Moorebank Intermodal Precinct West – Stage 2 Modification 2

Changes to construction related conditions
State Significant Development Modification Assessment
(SSD 7709 MOD 2)

September 2021

Figure 5 | Indicative location of maintenance tracks (highlighted yellow) (Base source: MOD 2 Application)

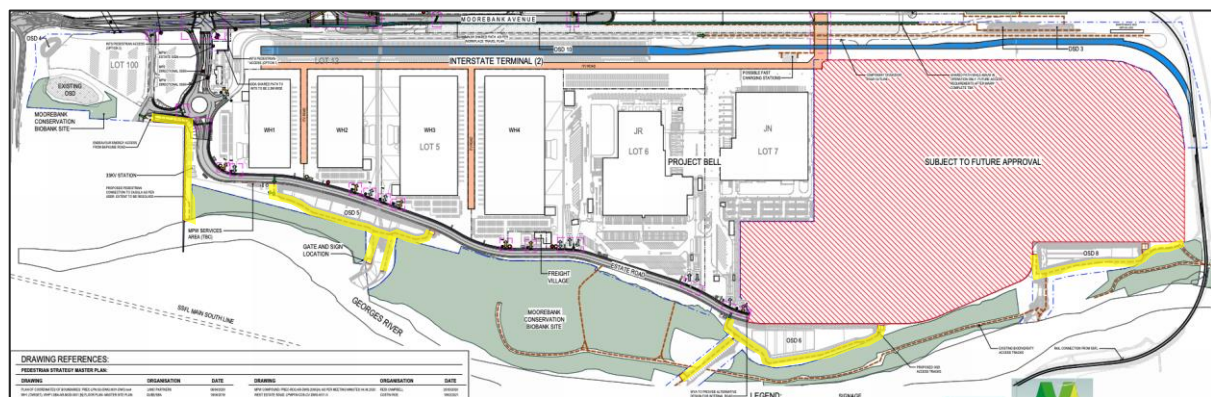
The modification is sought to carry out maintenance works without the need for a separate access track. Further, the Applicant advises access tracks may lead to unnecessary track maintenance requirements, additional costs, unnecessary additional urban heat island effects and stormwater runoff effects.

However, TfNSW noted that the indicative Masterplan submitted with the modification showing the access tracks (shown in Figure 5) does not appear to form part of this application, and therefore it has not been assessed and should be disregarded. The Department agrees, noting the Applicant has advised that this plan is indicative only, and that further changes may be made to the plan prior to it being submitted in accordance with Condition B2. The Department has not assessed the plan as part of this modification and recommends a condition clarifying that the indicative plan does not form part of the modification approval.

The Department is satisfied that necessary maintenance activities can be carried out as long as there are no impacts to the adjacent riparian corridor. Therefore, there is no need to provide a separate maintenance access track and the Department agrees with the Applicant that unnecessary tracks may lead to additional unnecessary impacts. However, the exact extent of the necessary access tracks will be a matter for determination at the time of submitting the amended development layout drawings.

The Department considers the above condition provides the Applicant with flexibility to only provide tracks where necessary and clarifies that the provision of the tracks is to be determined based on the need to protect the riparian corridors and adjoining sites.
